Docket Item # 6 & 7
BAR CASE #2012-0152 & 0153

BAR Meeting
June 6, 2012

ISSUE: Partial Demolition/Encapsulation and Additions/Alterations
APPLICANT: Alice Reid by Ray Lewis and Associates
LOCATION: 412 South Fairfax Street
ZONE: RM / Residential

PROPOSED EAST & WEST ELEVATION

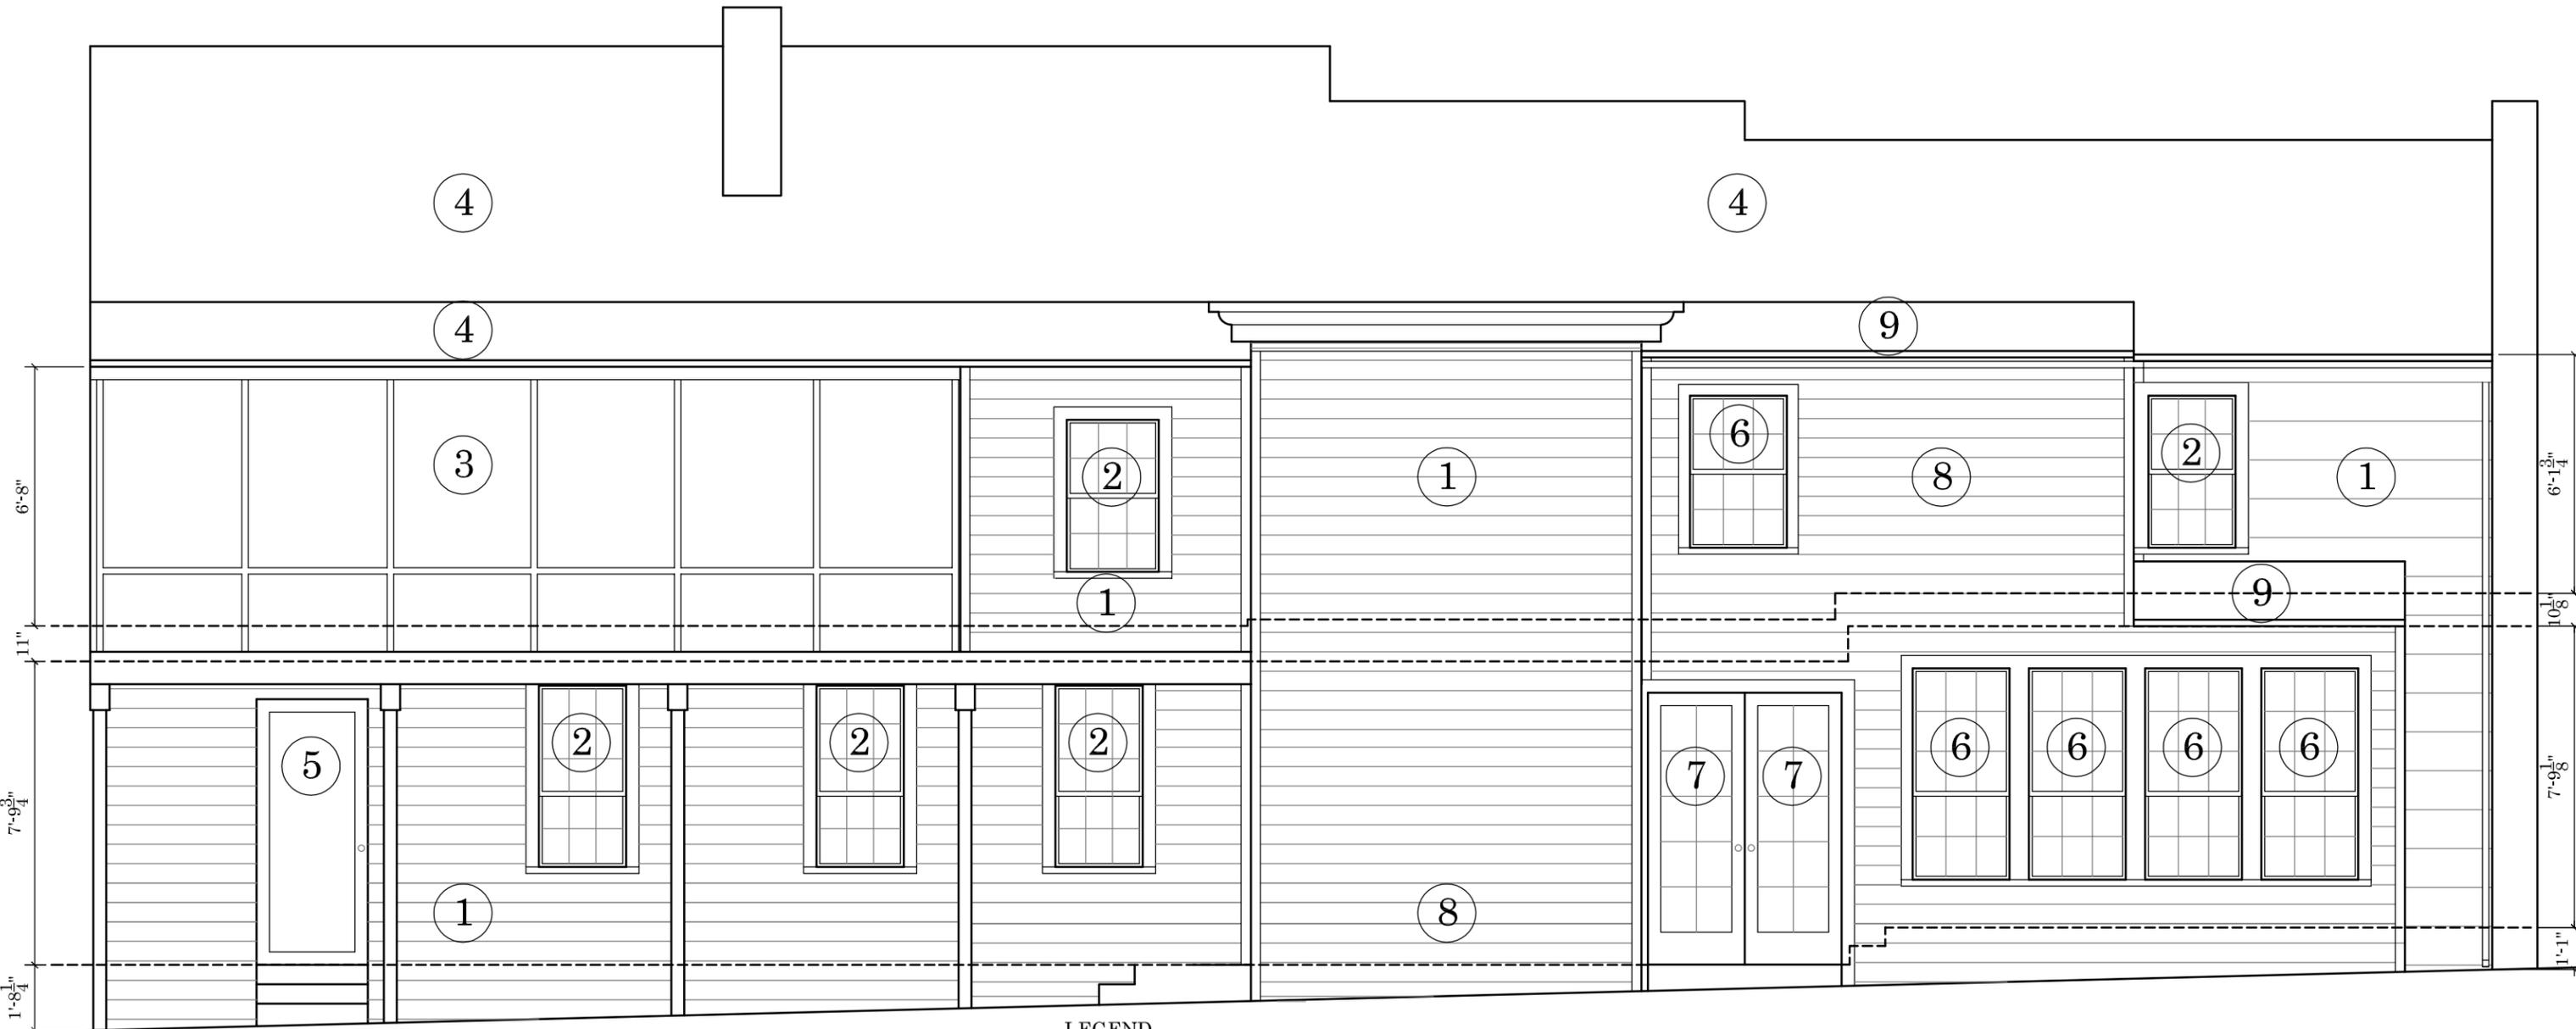
1. That the four-paneled door with four-light glass inset is changed to a painted wood, six panel wood door or a wood six panel door with glass in the top two panels.

2. That the painted wood siding on the new two-story addition match the exposure found on the existing 1970s addition.
3. That the following archaeology conditions appear in the General Notes of all site plans and on all site plan sheets that involve demolition or ground disturbance (including Basement/Foundation Plans, Demolition, Erosion and Sediment Control, Grading, Landscaping, Utilities, and Sheeting and Shoring) so that on-site contractors are aware of the requirements.
